## Accessibility Design Review Report

St. Michael's Uniting Church  
120 Collins Street  
Melbourne, Victoria

Dated: 09 December 2024

Reference: EG-241208-AC

3 Proposed Building Section  
Callout - Upper Auditorium  
1: 25 @ A1

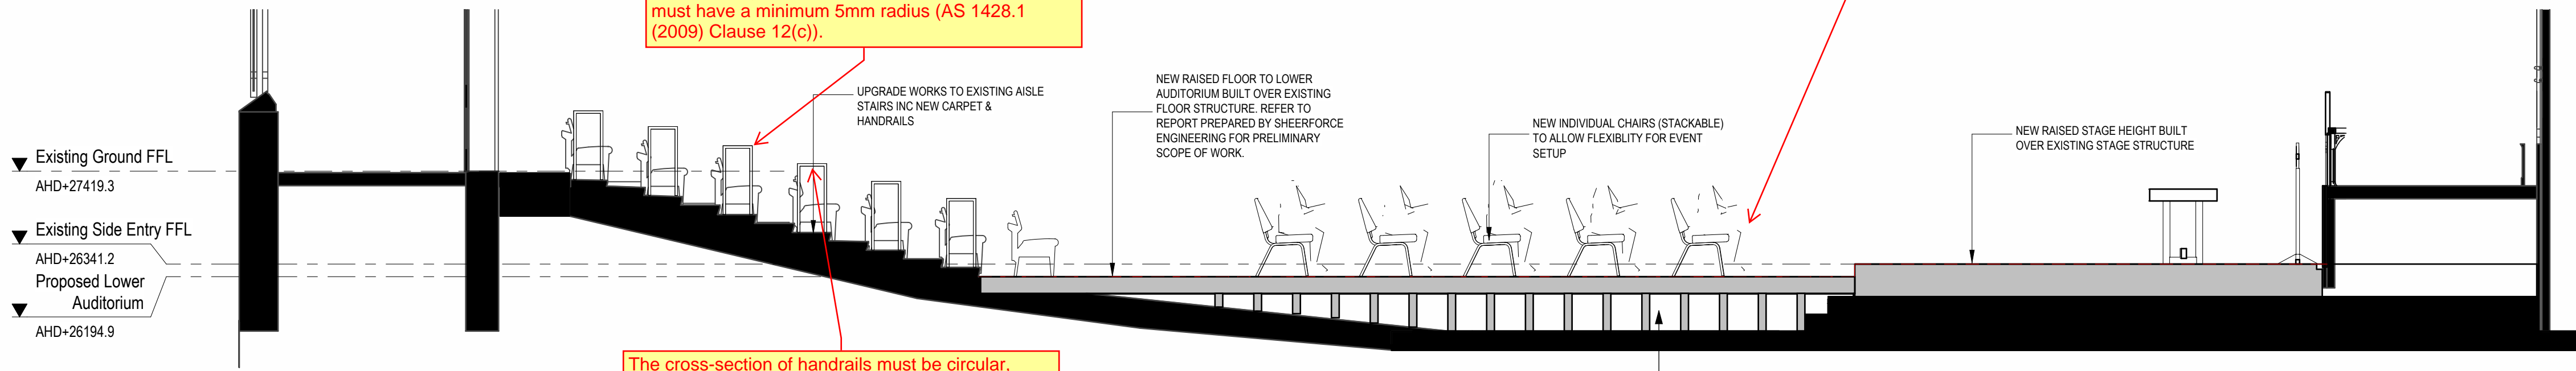
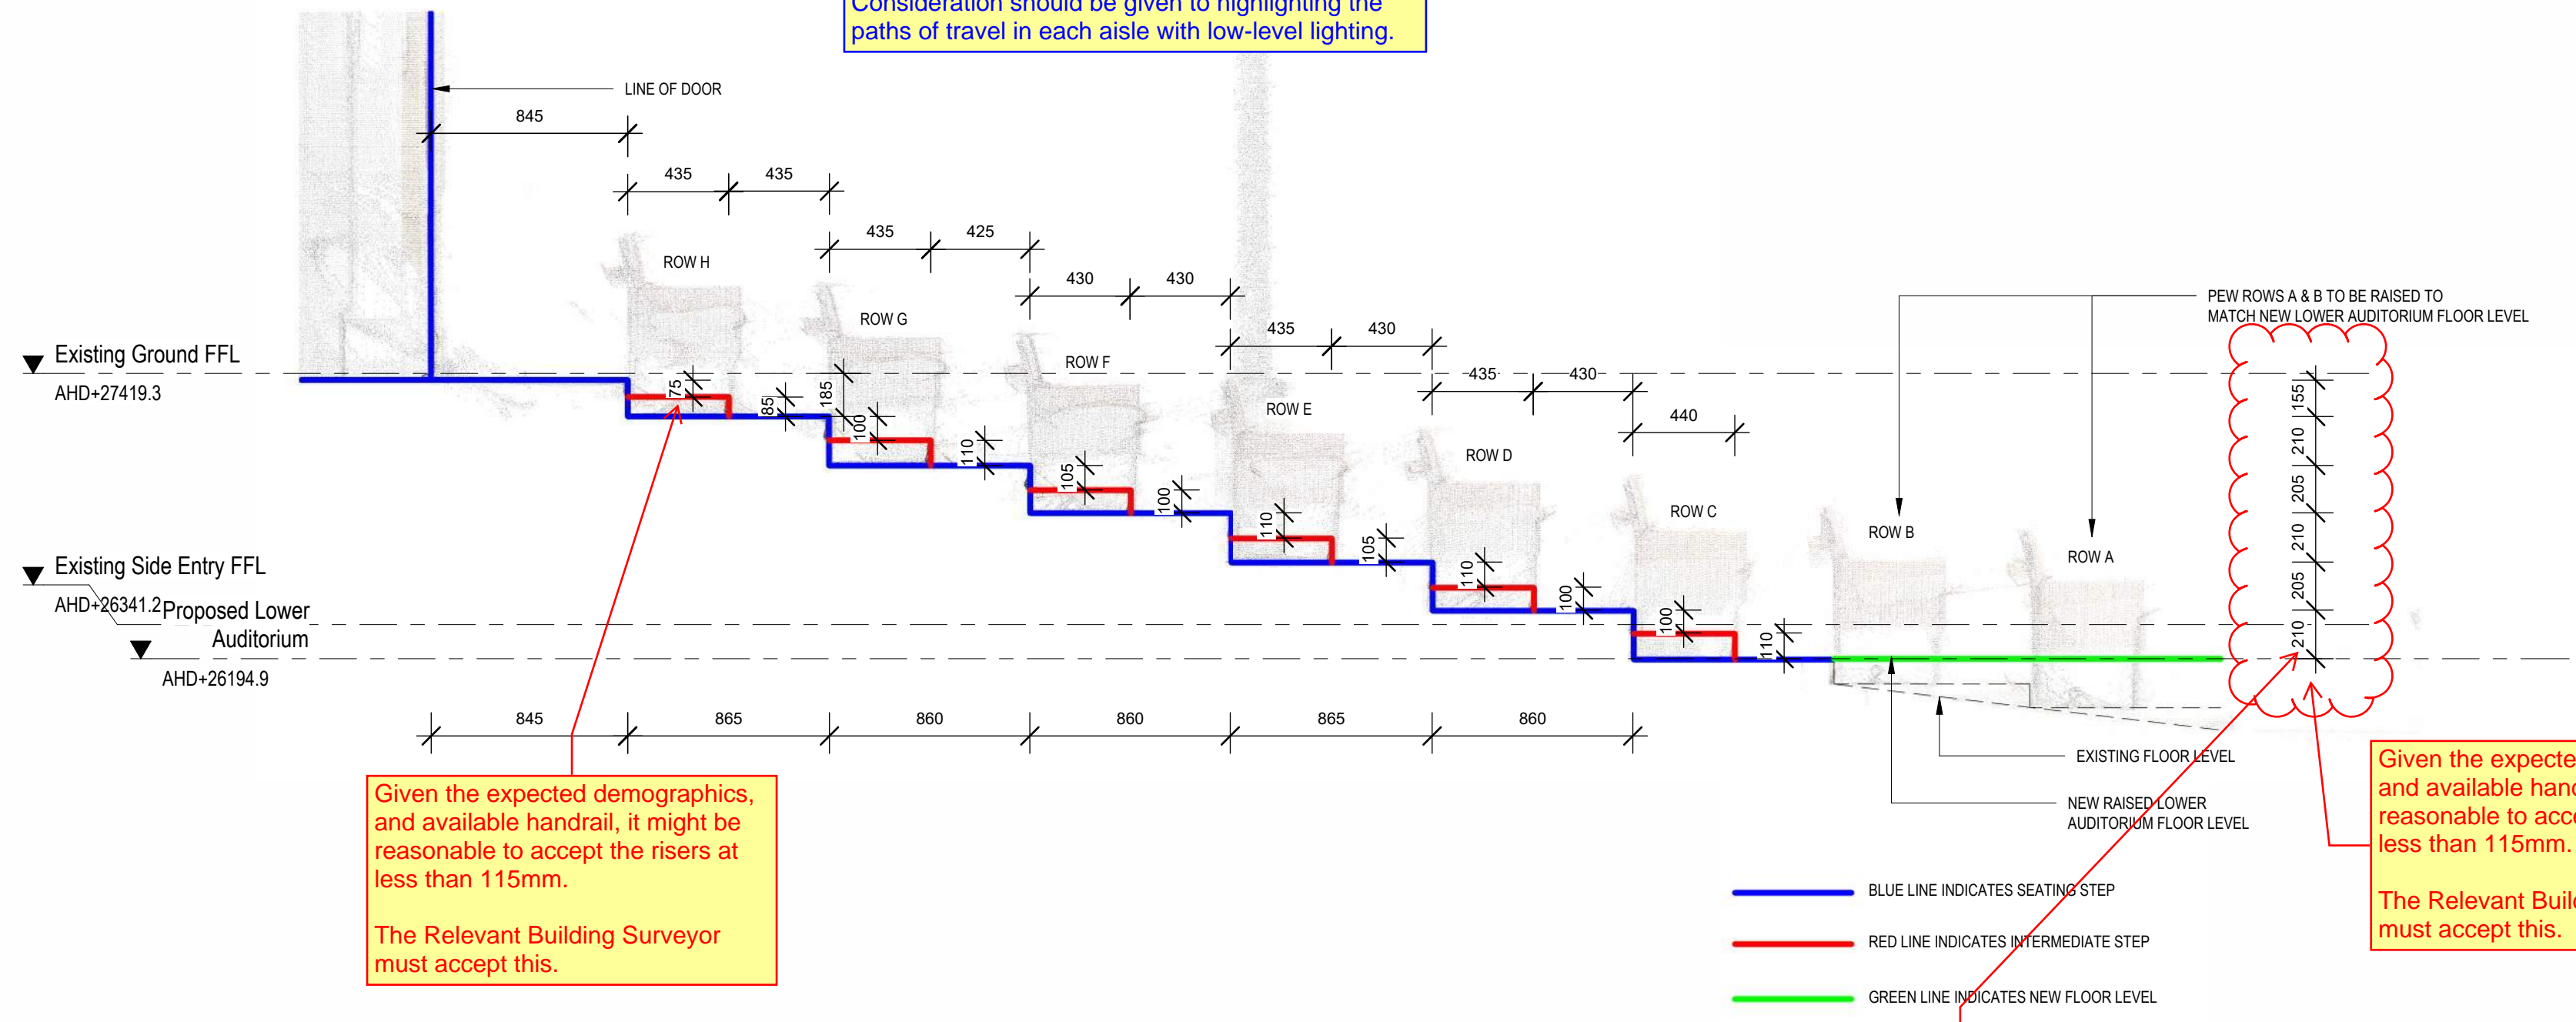
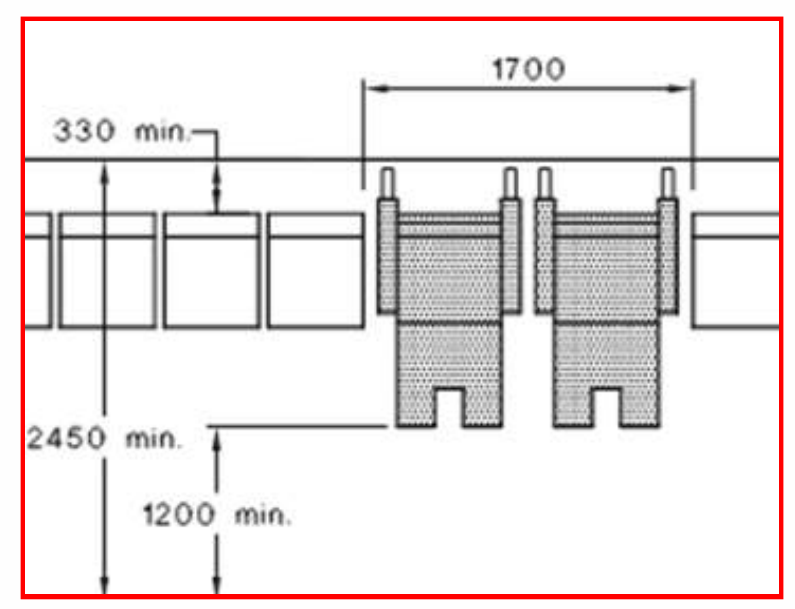
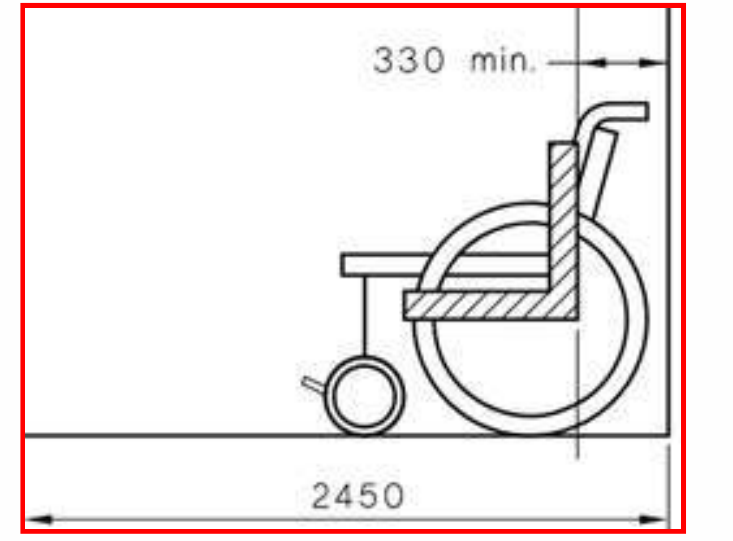
The clearance between a handrail and an adjacent wall surface or other obstruction shall be not less than 50 mm. This clearance shall extend above the top of the handrail by not less than 600 mm (AS 1428.1 (2009) Clause 12(h)).

The top of handrails must be between 865mm and 1000mm above the nosing of stairway tread or the plane of the finished floor of the walkway, ramp or landing (AS 1428.1 (2009) Clause 12(d)).

Removable/loose seating is an acceptable alternative.
